OAKDALE WEST ESTATE - SSDA 7348 - MOD 5 Submission Civil Changes

This letter addresses the primary changes in the design at Oakdale West Estate for the Masterplan and the Precinct 1 on-lot design for the Modification No. 5 Application to SSDA 7348.

Project
PROPOSED INDUSTRIAL DEVELOPMENT OAKDALE WEST

b) Precinct 1 Lots Carpark Layout & Driveways

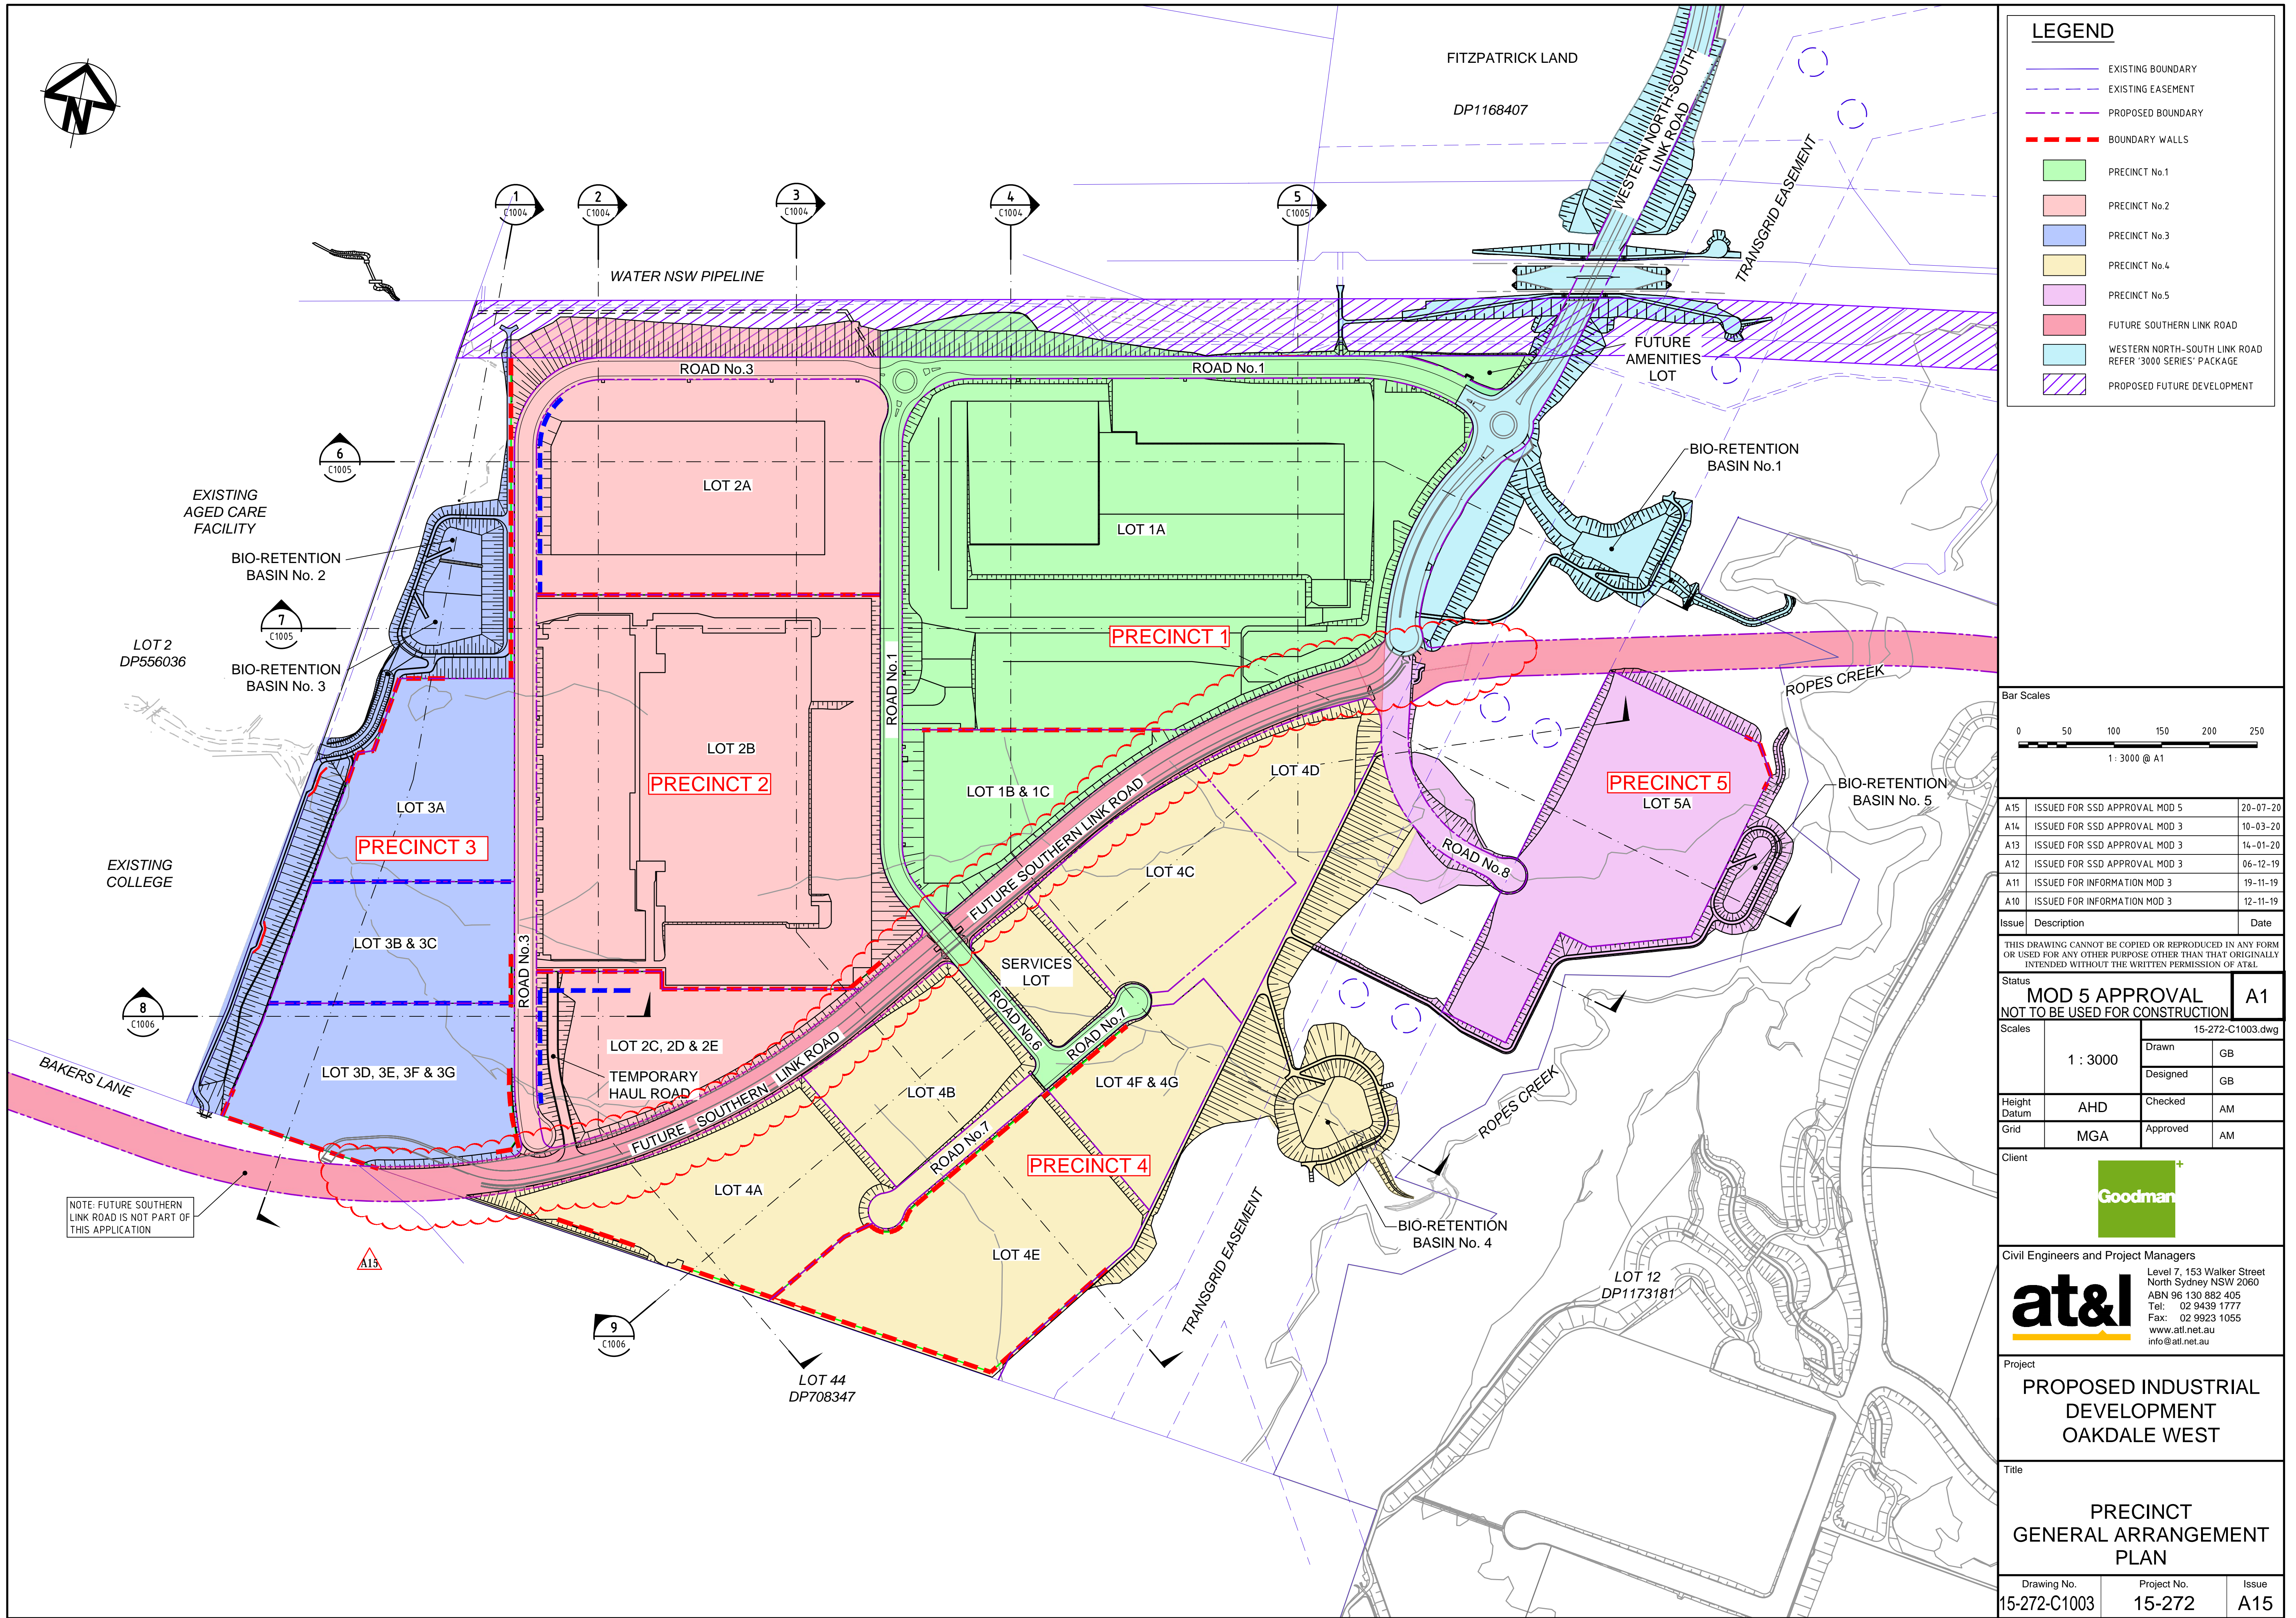
The Lot 1A and 1B layout has been updated to rearrange the carparking and hardstand areas in line with the architectural changes. The stormwater catchments and overland paths remain very similar and have no impact on the modelling for the infrastructure throughout the estate. This is shown on drawings C2000-C2030.

Title
TYPICAL SITE SECTIONS SHEET 1 OF 6

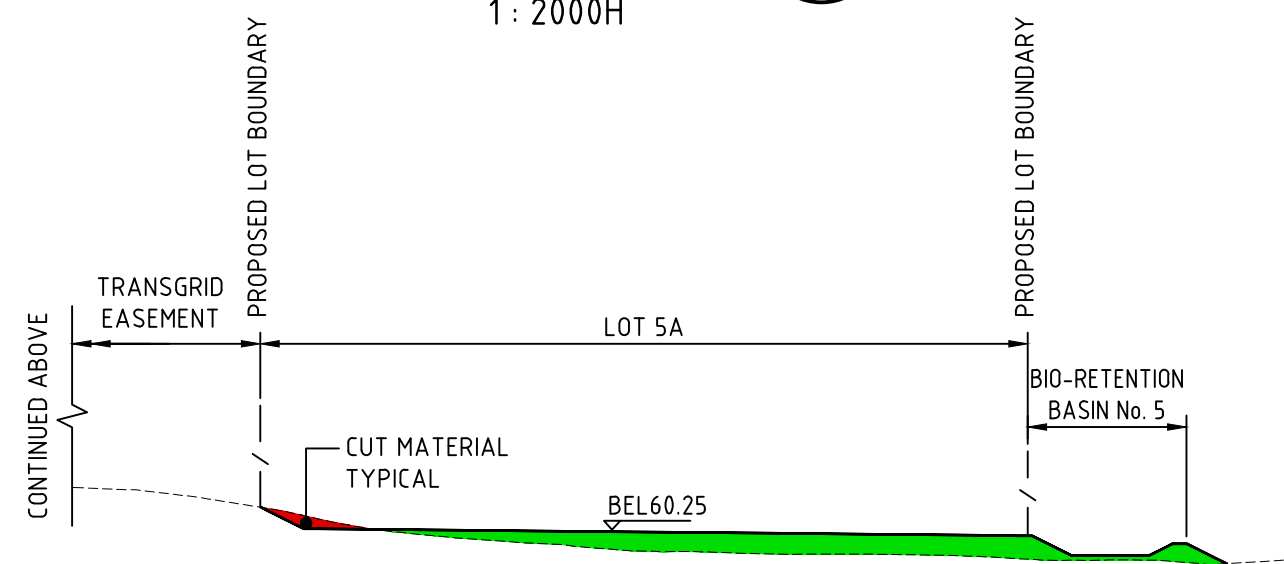
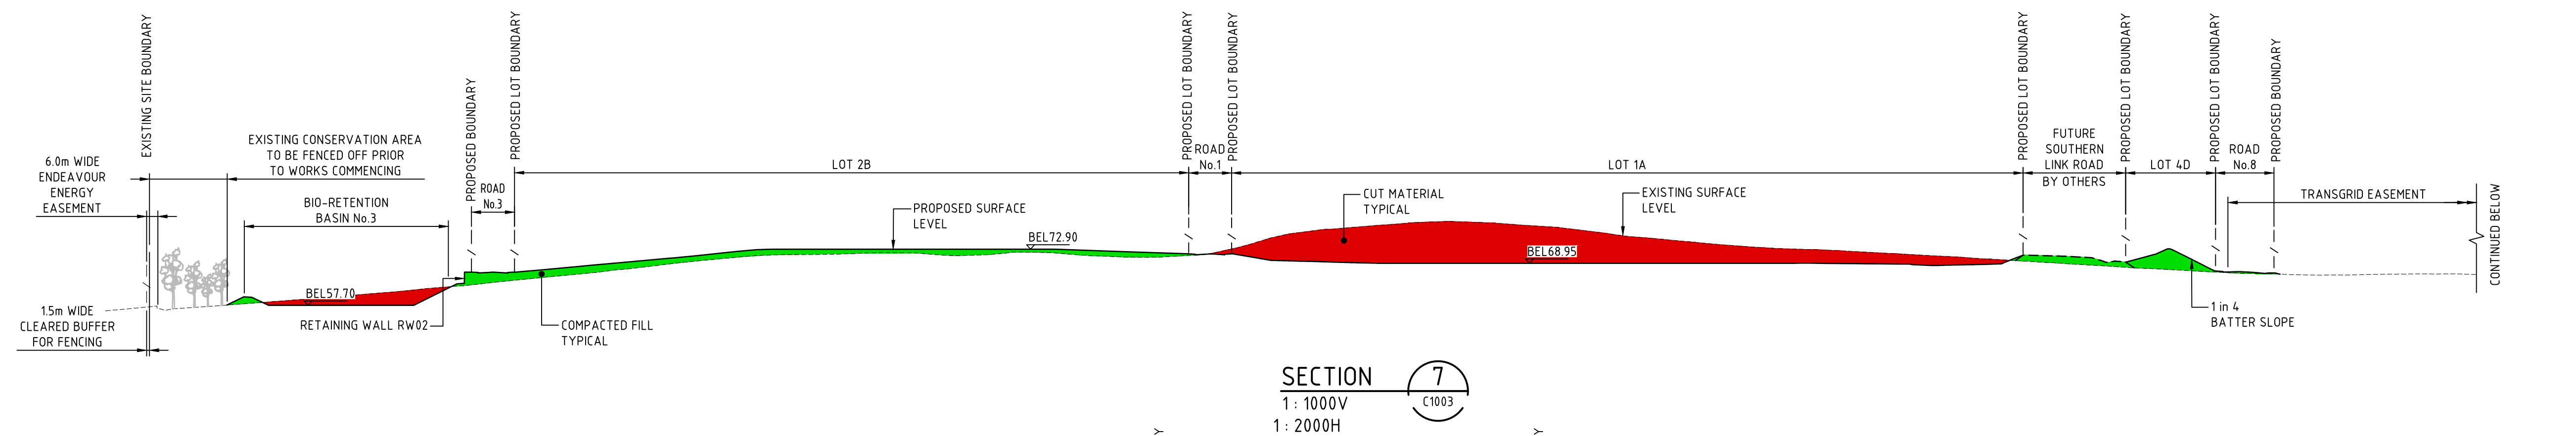
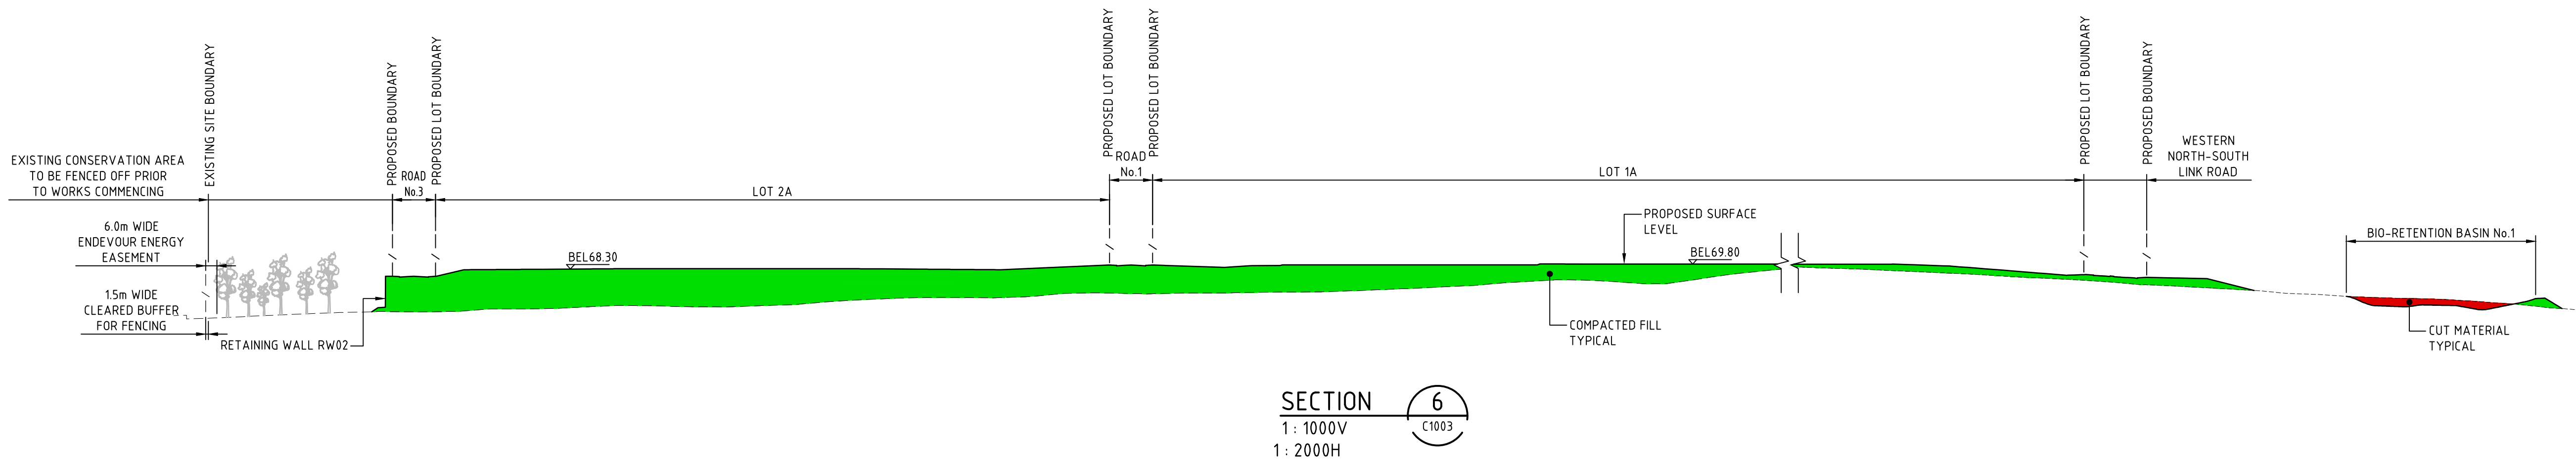
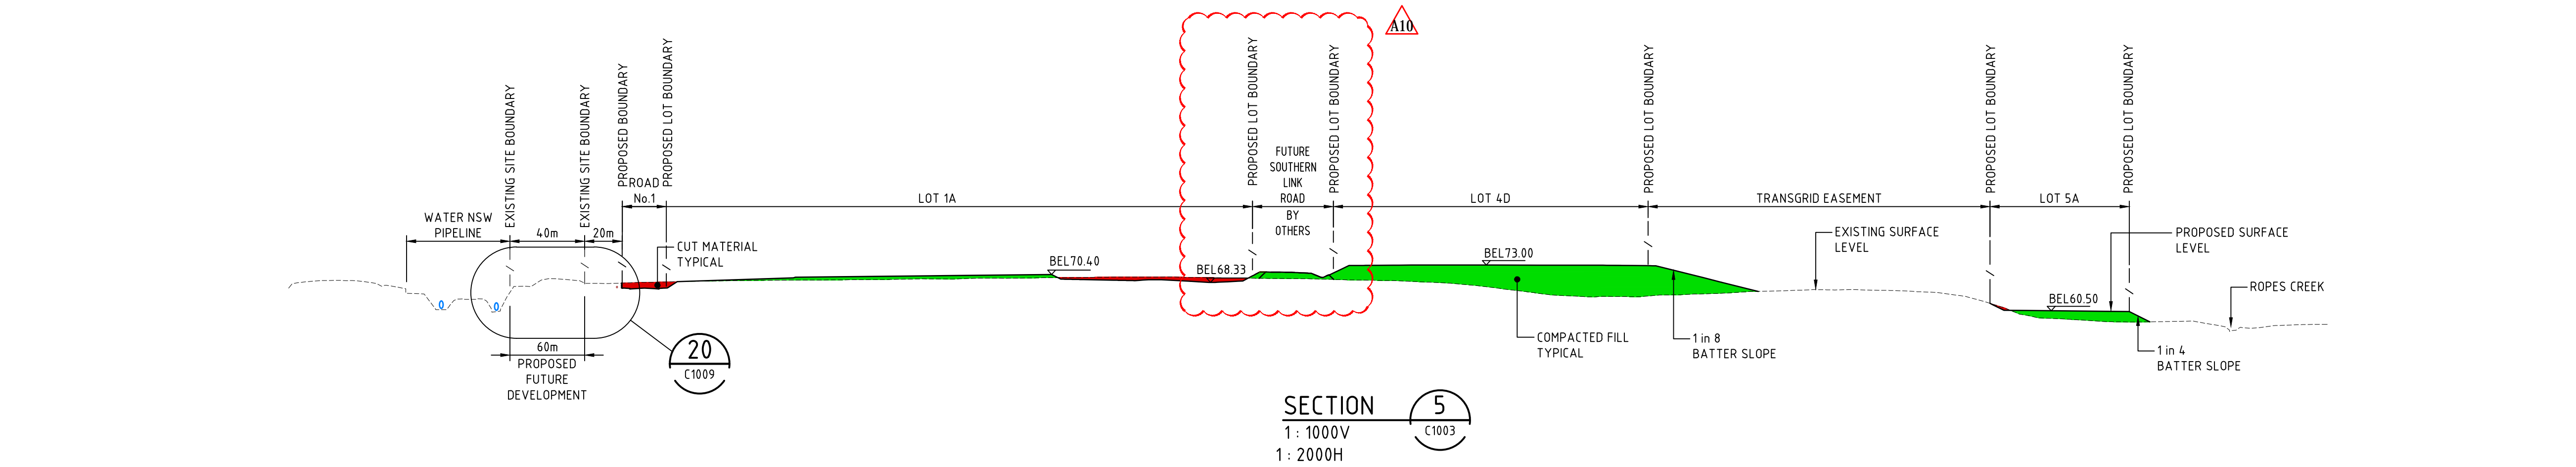
Boundaries on the Future Southern Link Road have been widened as per consultation with Council and TfNSW. This is shown on updated masterplan drawings C1003, C1004 and C1005.
